# SERVICE BULLETIN

M-1382

## 2014 FL TOURING HYDRAULIC CLUTCH - SAFETY RECALL CODE 0159

Figure 1. Recall Kit 91500068

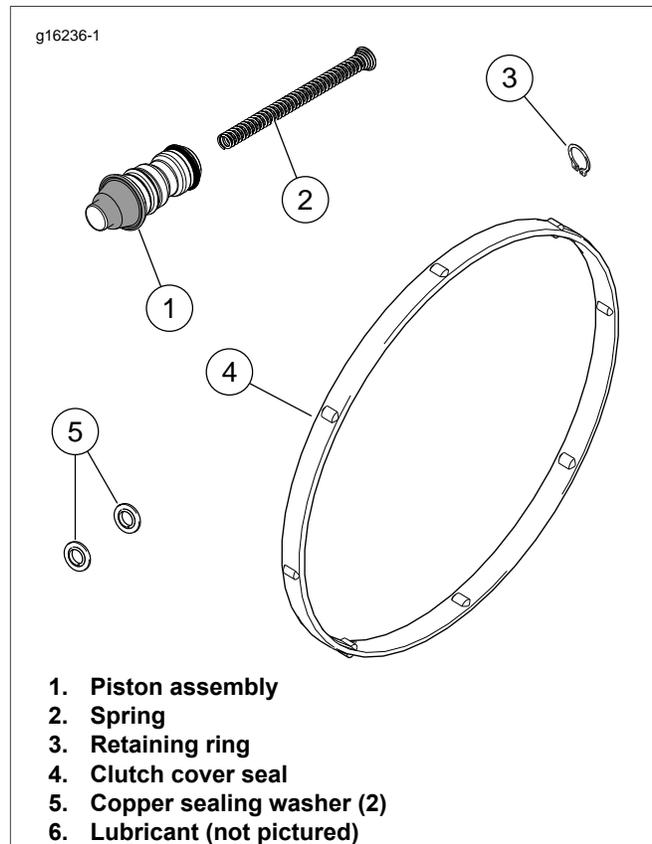
These motorcycles may develop a tear in the primary cup (seal) on the master cylinder piston. If this condition occurs the system may lose the ability to maintain enough lift to keep the clutch disengaged. If this condition remains undetected, it could allow the motorcycle to "creep" forward from a stop, which could lead to a loss of control of the vehicle possibly causing a crash.

Do not reuse any parts removed from the master cylinder piston bore. Use only the parts from the kit.

1. Confirm that the motorcycle is involved in Recall 0159. If the status includes an **open** for Safety Recall 0153, the 0159 should be performed and the 0153 will be closed by HDMC once the 0159 claim is approved.
2. Obtain the recall kit (Part No. 91500068).
3. Replace the clutch master cylinder piston assembly with parts from the recall kit. This kit is to be used on both original equipment clutch master cylinders and chrome accessory clutch master cylinders (Part No. 41700263 and 41700263A). See CLUTCH MASTER CYLINDER AND RESERVOIR in the service manual.
4. Fill and bleed clutch fluid system. See the service manual.
